May 4, 2016

Daniel Thomas, Principal Planner
Christopher Snyder, County Engineer
DuPage County Division of Transportation
421 N County Farm Road
Wheaton, IL 60187

On behalf of our members and other bicyclists we represent, thank you for the opportunity to review upcoming DuPage County DOT road projects for impacts on bicyclists and pedestrians.

31st Street at IL 83 (part of IL 83—Jorie project)

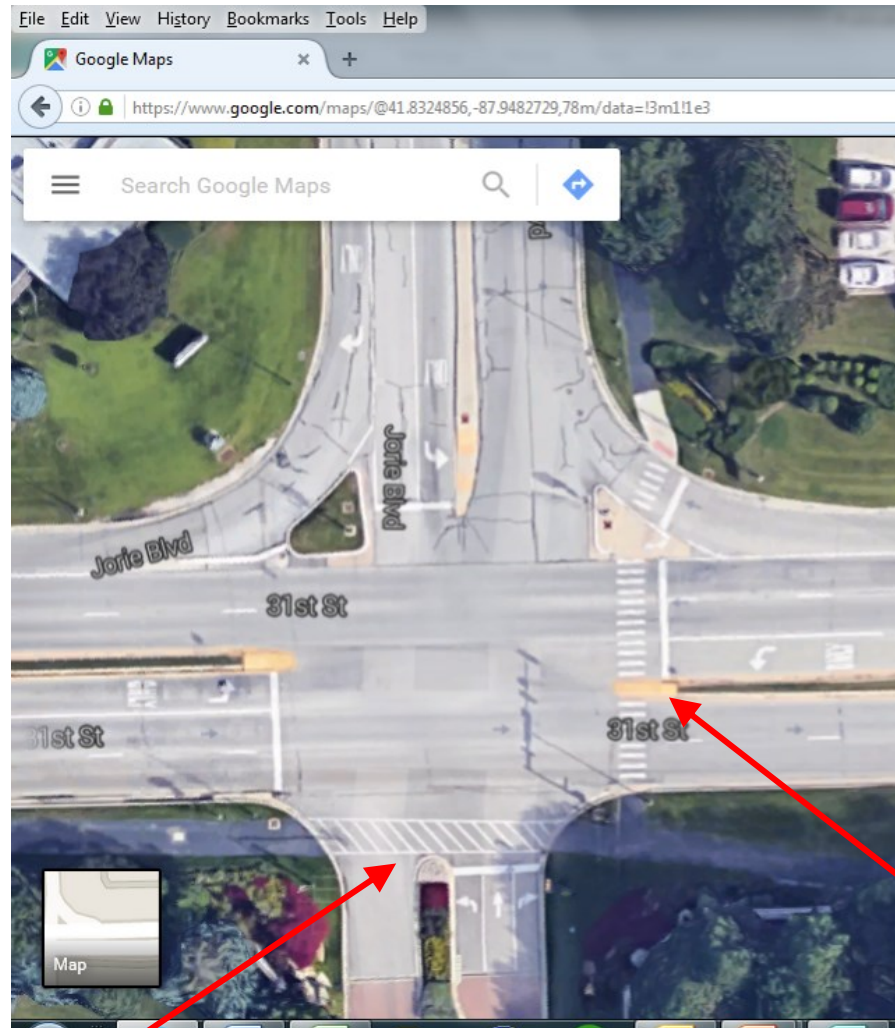
Recommended: Bring the sidepath trail's crossing closer to 31st for better visibility as "part" of the intersection—but maintain the perpendicular crossings. Move the right turn lane out further to allow for a larger corner island, and use this island in the sidepath crossing. Doing so also isolates turning motion conflicts and allows sidepath users to cross to the island during west-bound 31st turns onto southbound IL83—thus avoiding conflicts with east-bound 31st right-turners when the signal turns to green. Provide good visual delineation for the crossing, perhaps using continental crosswalks.

Recommended: Bring the sidepath trail's crossing closer to 31st. Try to cross the right-turn lane more perpendicularly. Continue to use a corner island in the sidepath crossing. Refresh the zebra/diagonal crosswalk or go to continental style.

87th Street at Woodward

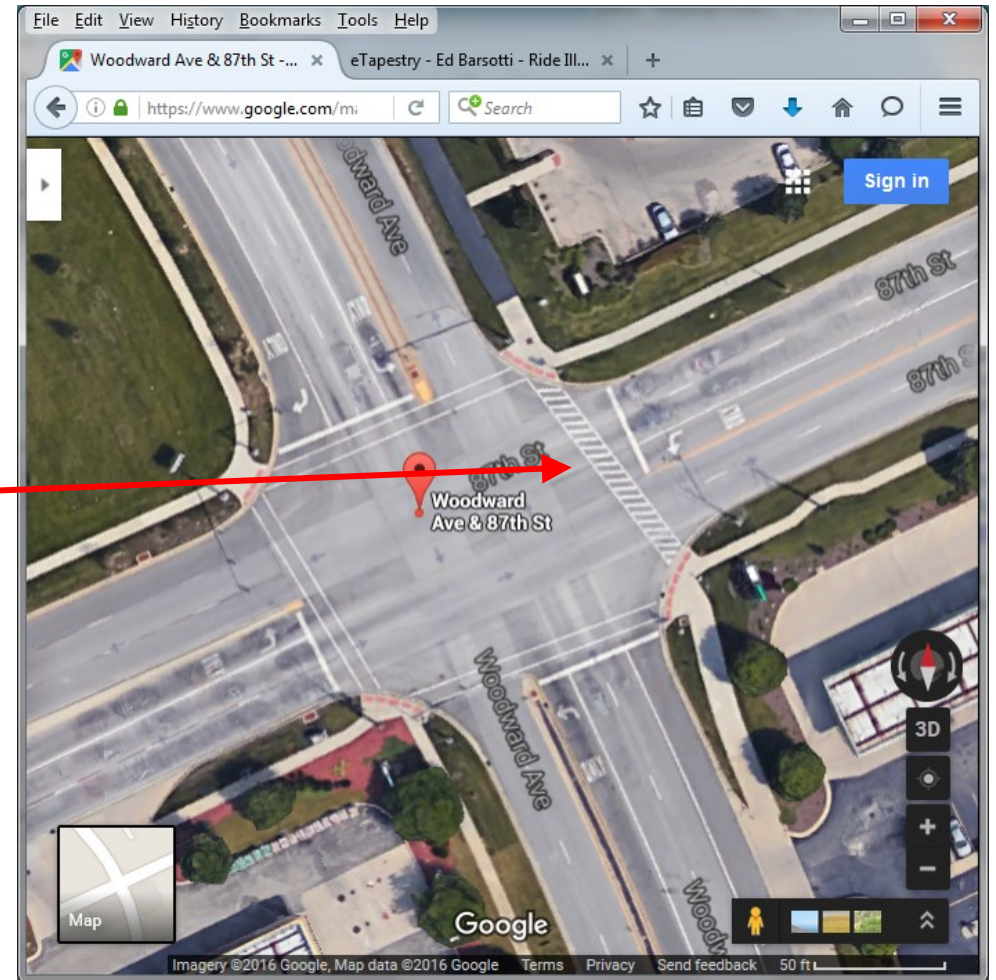
Recommended: Add right-turn corner islands. Priorities are the northeast and southeast corners, due to the sidepath trail crossing. Adding these will isolate turning motions faced by bike/ped sidepath users, and reduces natural conflicts such as one between northbound motorists turning right and northbound bike/ped sidepath users crossing 87th. Corner islands bring the crossing closer to Woodward, improving visibility. Traffic operations can be helped with shorter crossing distances.

County Farm Rd S-Curve Project

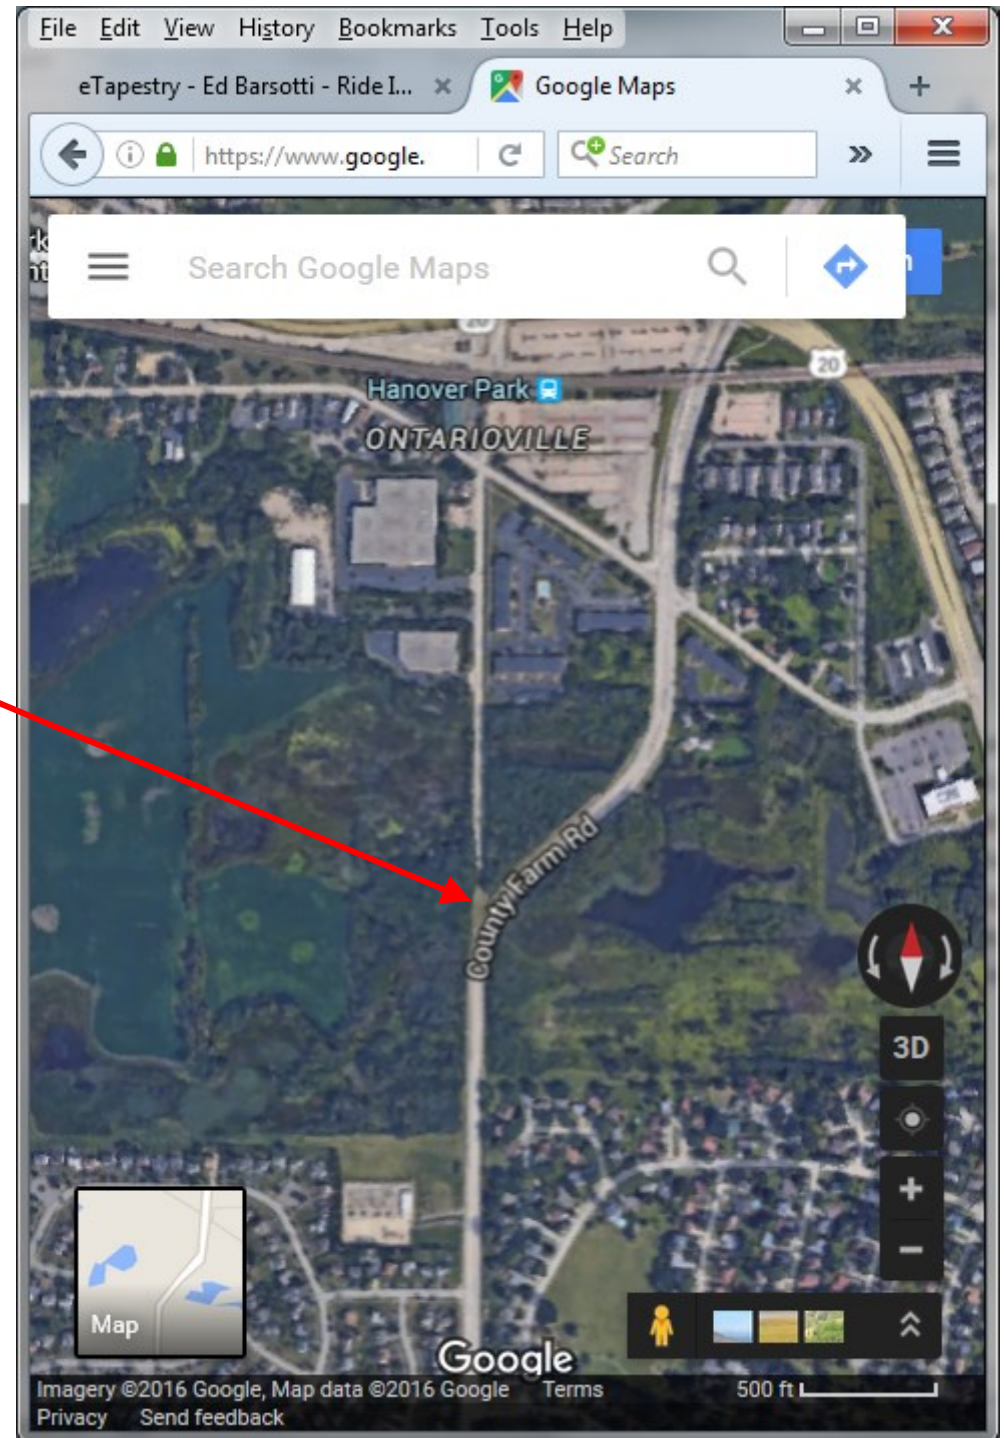
Recommended: As part of this IDOT Highway Safety Improvement Program project, please also improve the safety of pedestrians and off-road cyclists by closing the important sidewalk gaps there. A short sidewalk link connecting a west sidewalk (or sidepath trail) to Church Road would be helpful, too—as evidenced by the “desire line” worn there already.

75th Street at Fairview Ave (part of Lyman-Adams project)

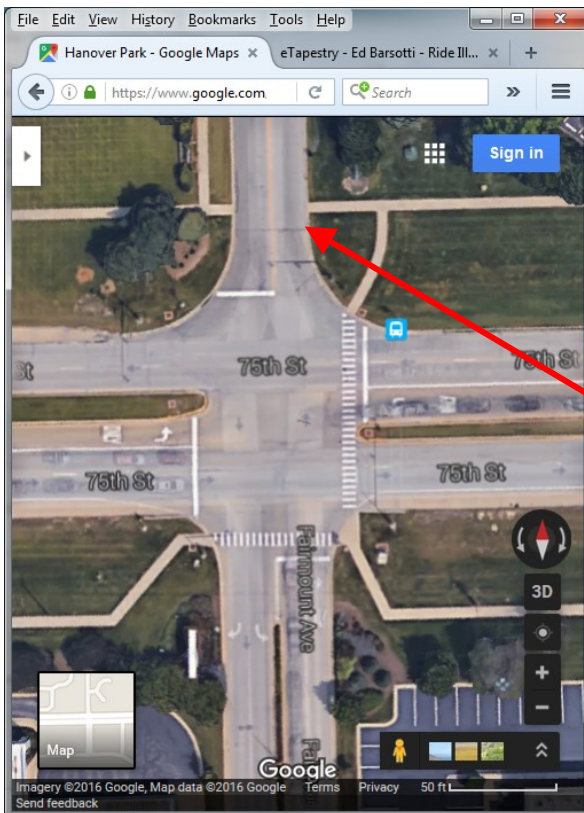
Recommended: Top priority—Bring sidepath trail and sidewalk crossings of Fairview closer to 75th Street. These are now too far back, at unrealistic locations to expect motorists to stop. Also, right-corner islands would improve any of the corners, although the northeast and southeast corner are higher priority due to the sidepath trail crossing.

75th Street at Fairmount

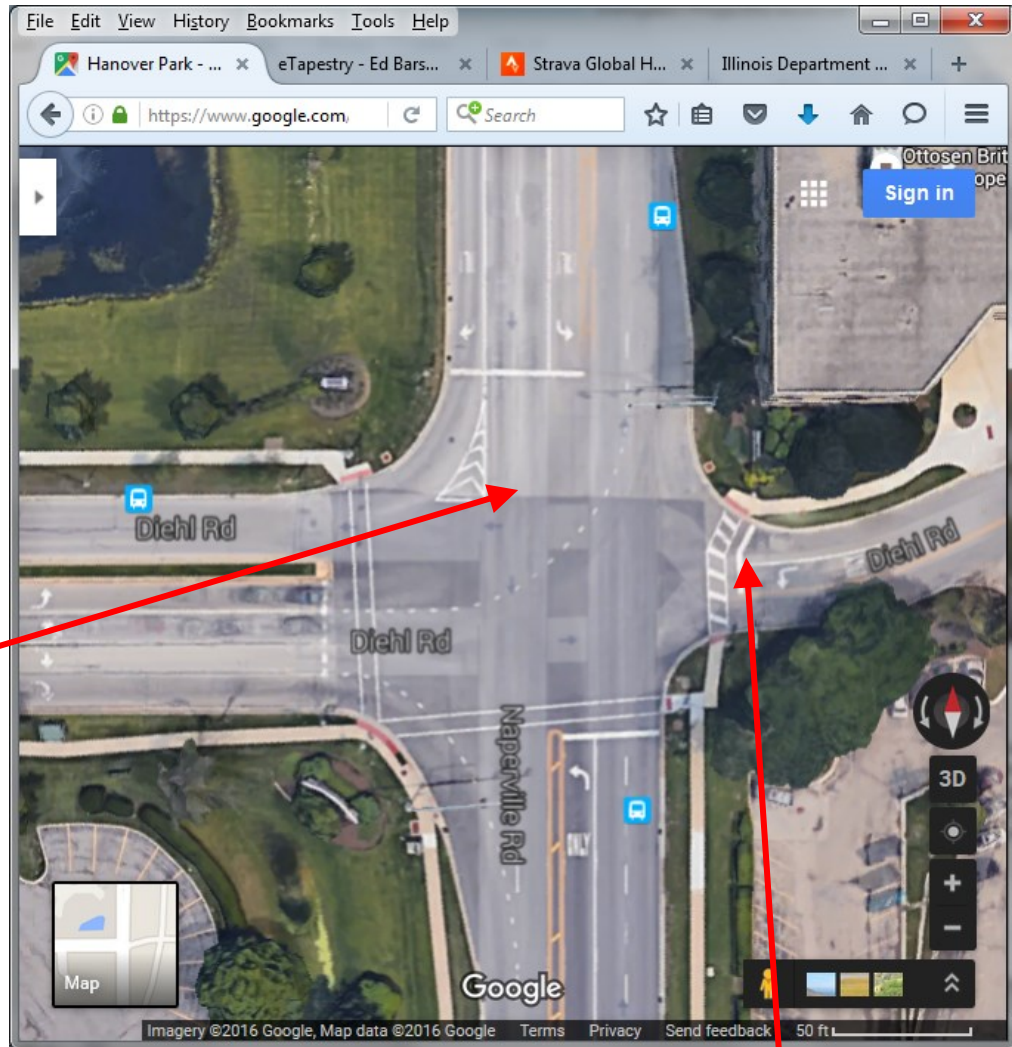
Recommended: At many intersections and other entrances, the sidewalk is brought close to the parallel road. This improves visibility and prevents bicyclists and pedestrians from being blocked or having to pass through a queue of cars—dangerous from a visibility standpoint. Other crossings, however, are too far back and placed behind the stopline. If there is an opportunity to correct this, it would help.
